## Change Order Request

Job: Ann Arbor Wheeler Center

Change Order #: 1

## Ann Arbor Wheeler Center – Design Change Engineering & Management Fees

SHEET:  
PV100

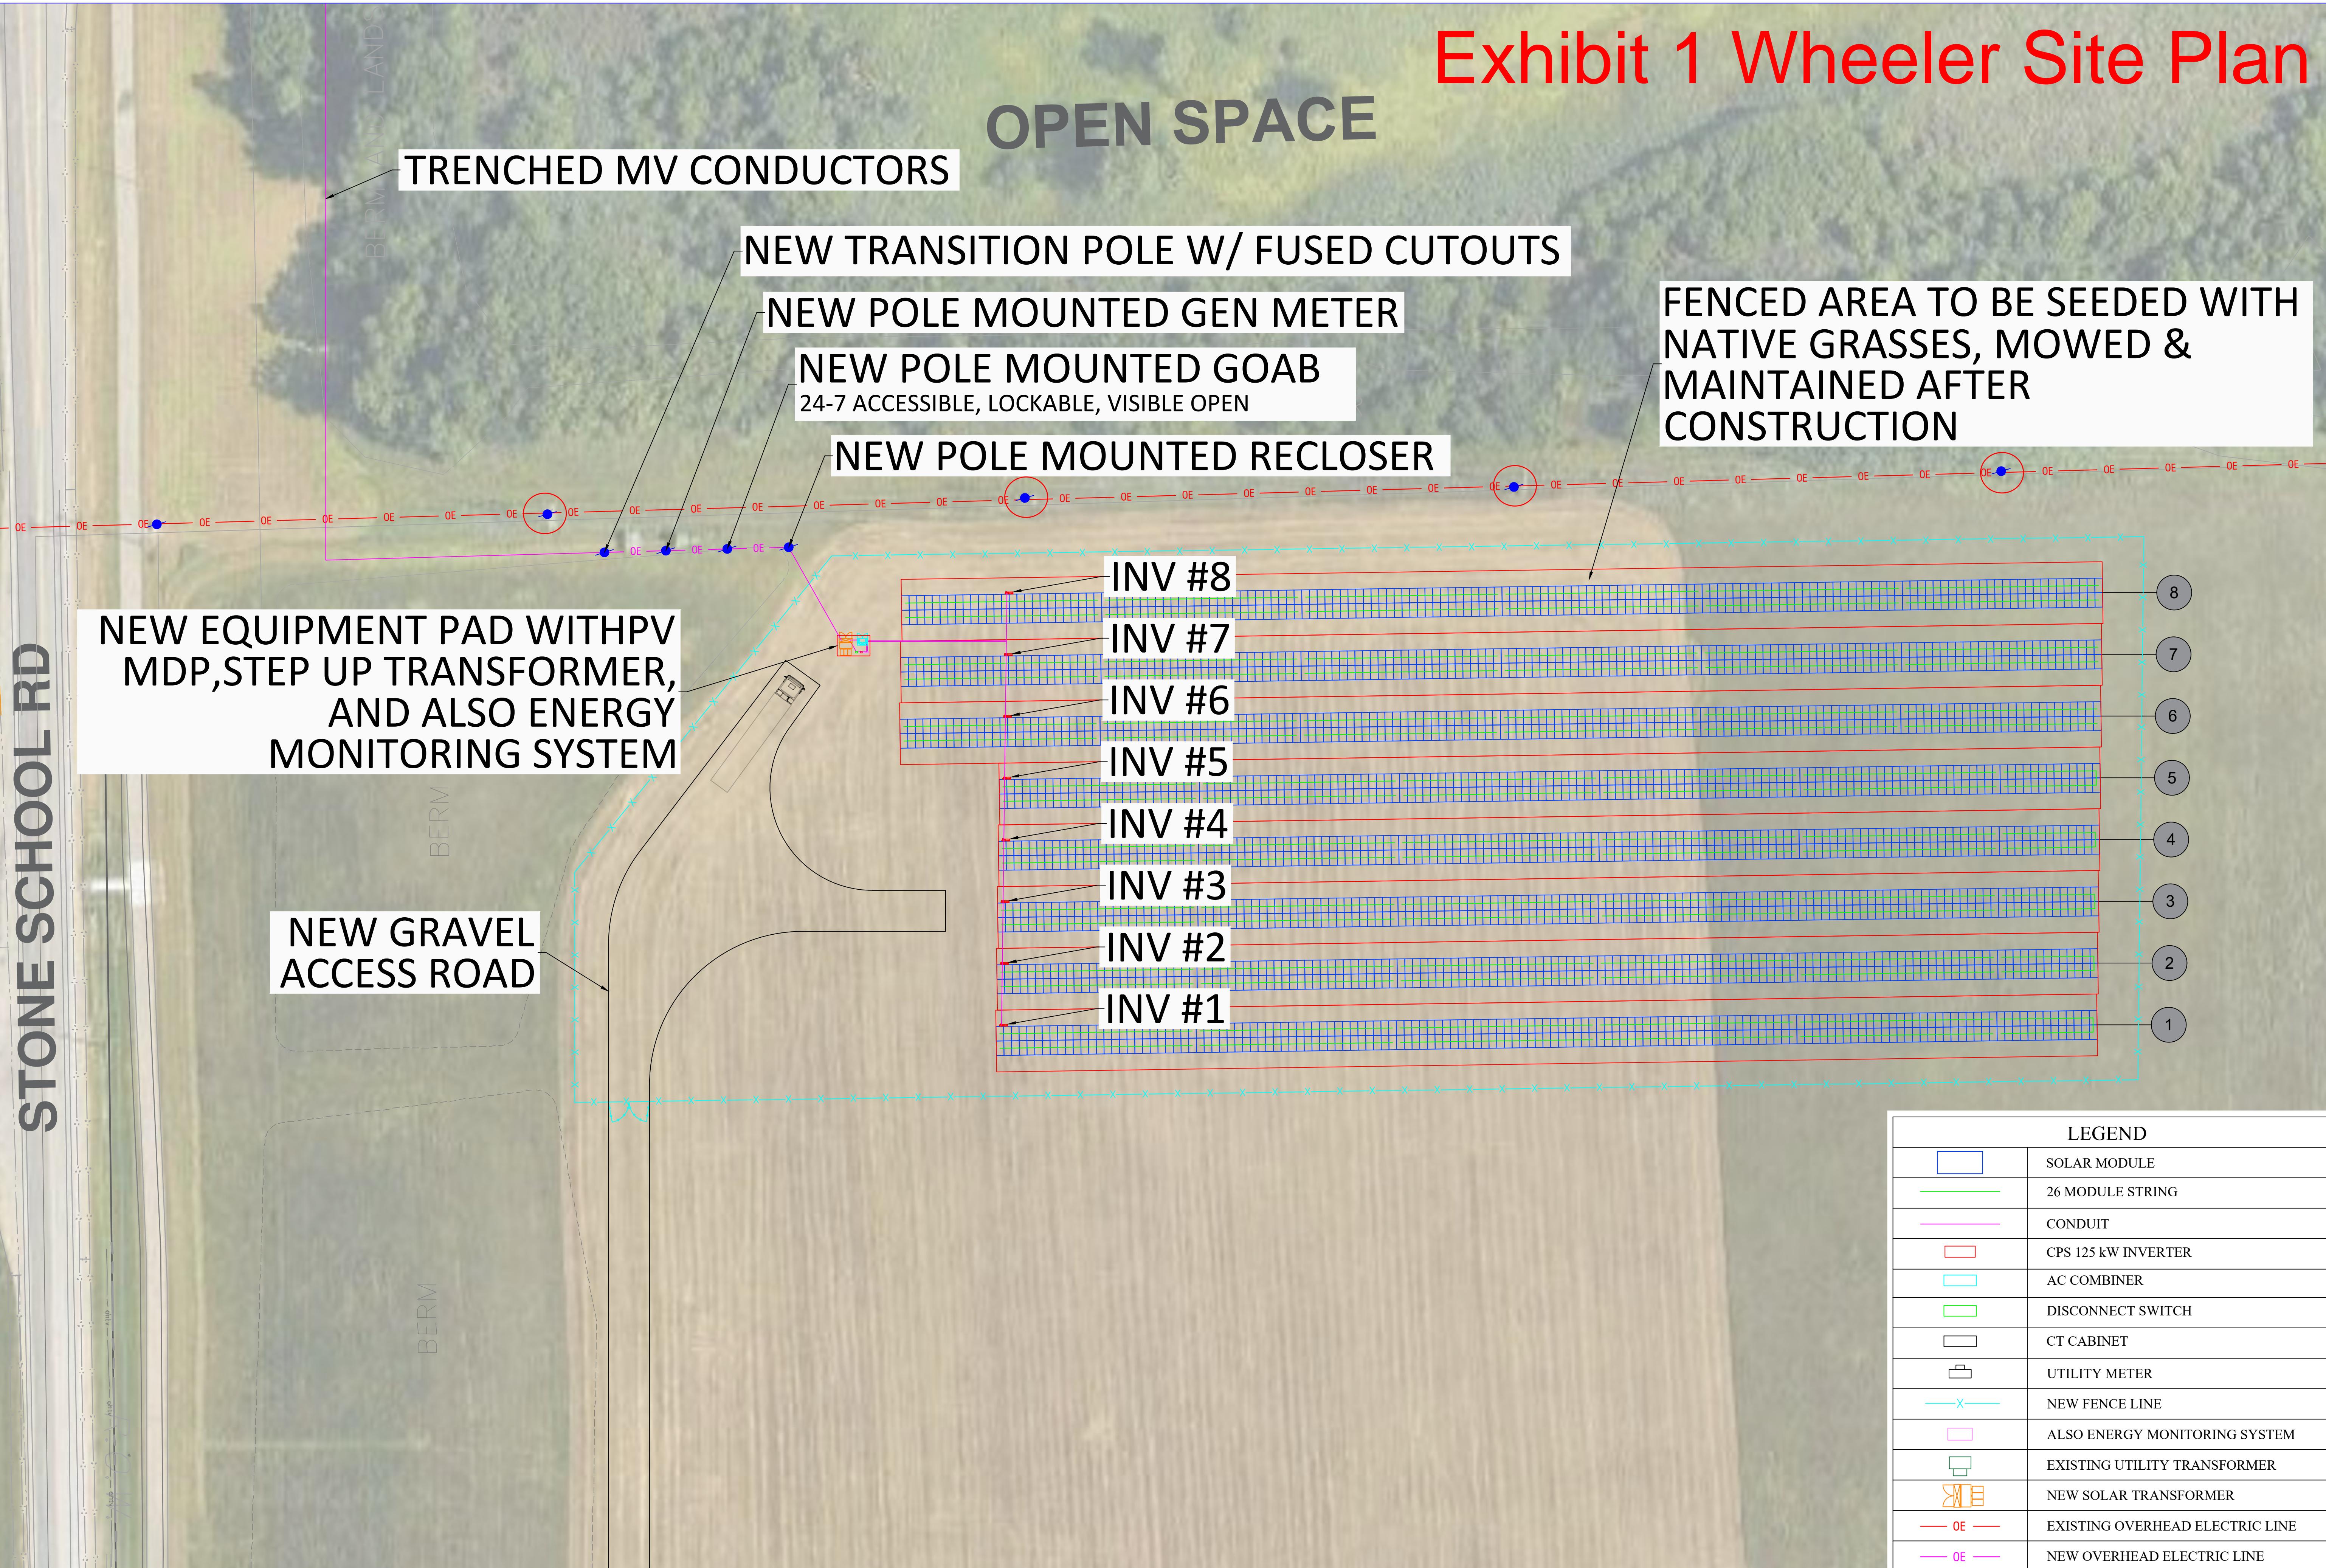
**Task #1 – 20' Gravel Access Road Design: (See Attached Exhibit 1 – Wheeler Site Plan)**

1. Existing conditions topographical survey
2. 20' Gravel access road designed for heavy Duty Truck Traffic
3. 3-point truck Turn around at Solar Array
4. Provide Construction details & quantities / Bid Form
5. AutoCAD / PDF file will be Provided
6. Provide Stamped Drawings Suitable for Permit submission.

SHEET:  
**PV101**

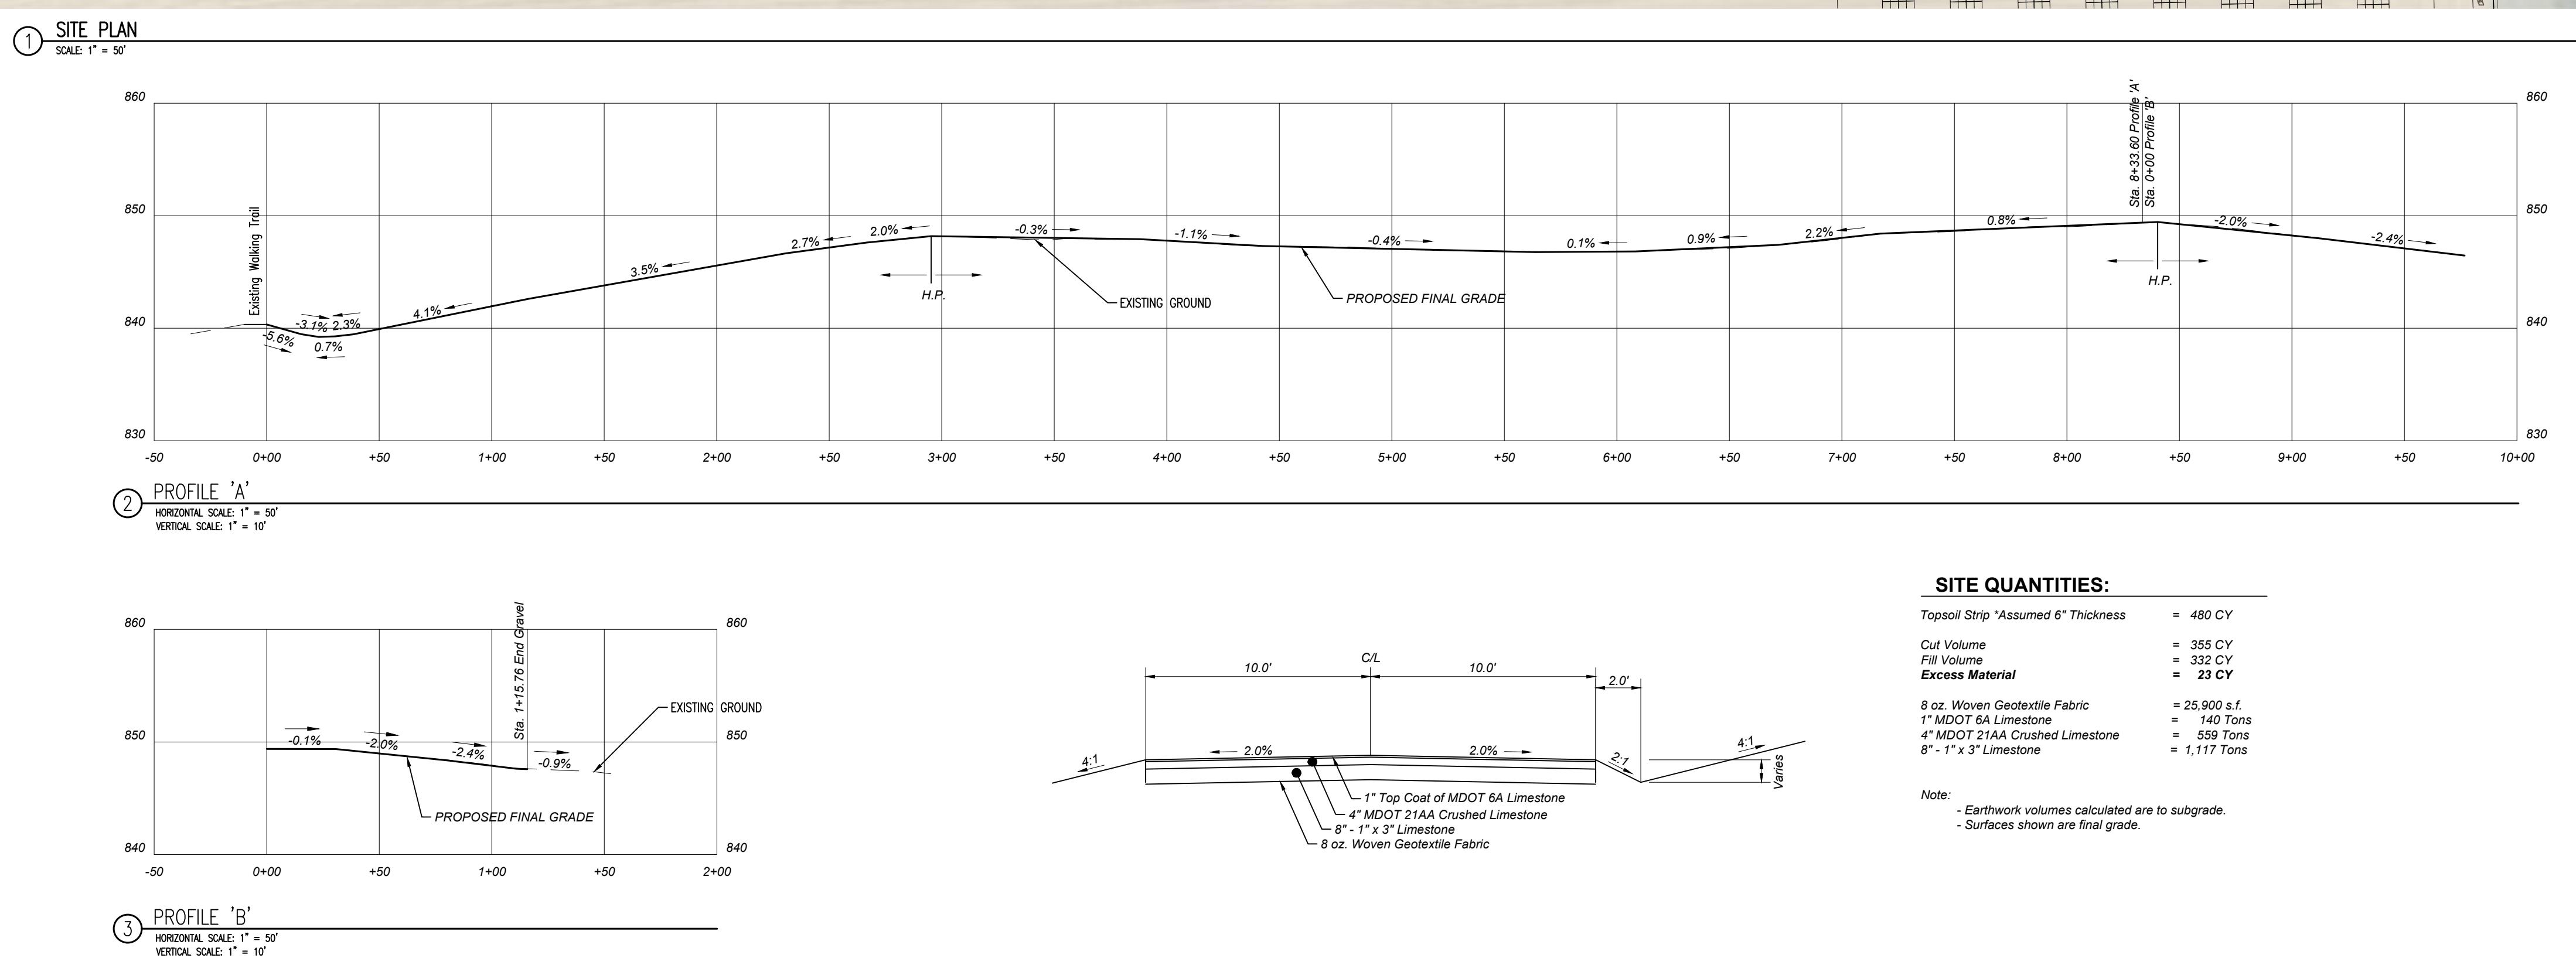
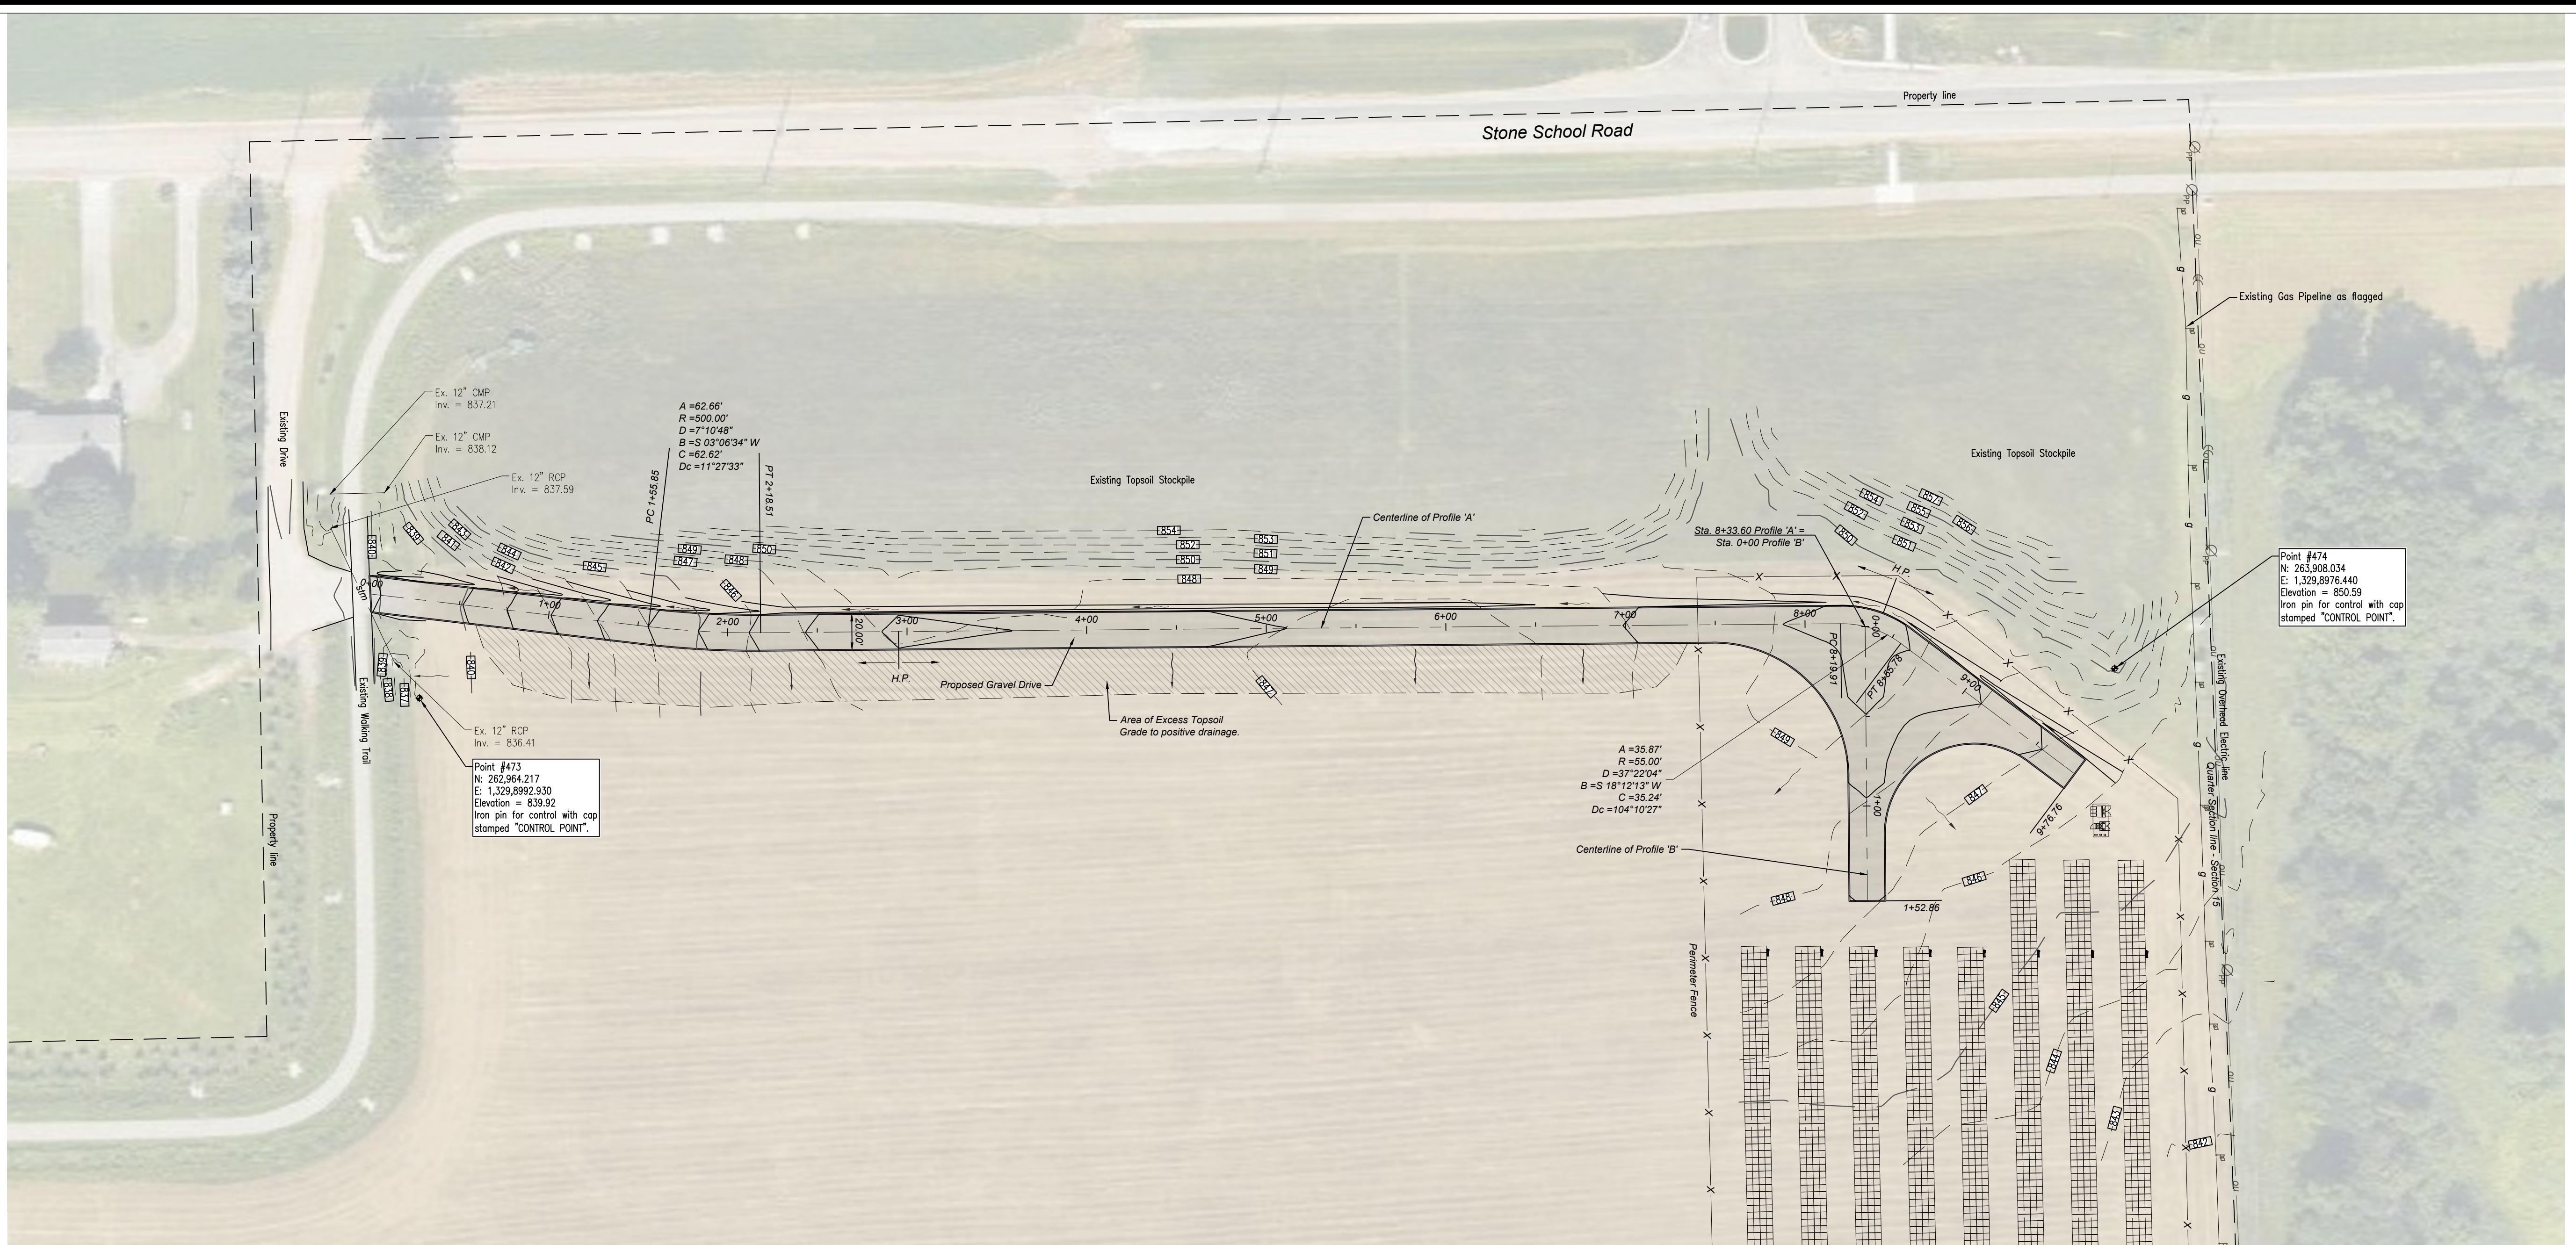
Item	Amount	Notes
Access Road Engineering	\$ 8,500.00	Civil engineering fee for new access road design
Internal Eng/PM	\$ 9,000.00	Melink fees for re-engineering the array in different locations
Electrical Increase	\$ 134,181.00	Longer IX run back to tie-in
Subtotal	\$ 151,681.00	
OH/Profit (15%)	\$ 22,752.15	Per contract, 15% markup on CO's
Melink Total	\$ 174,433.15	
DTE Upgrades	\$ 108,000.00	New fuses, commissioning, and SCADA
Access Road - Deduct	\$ (17,000.00)	Removal of original access road cost
<b>Grand Total</b>	<b>\$ 265,433.15</b>
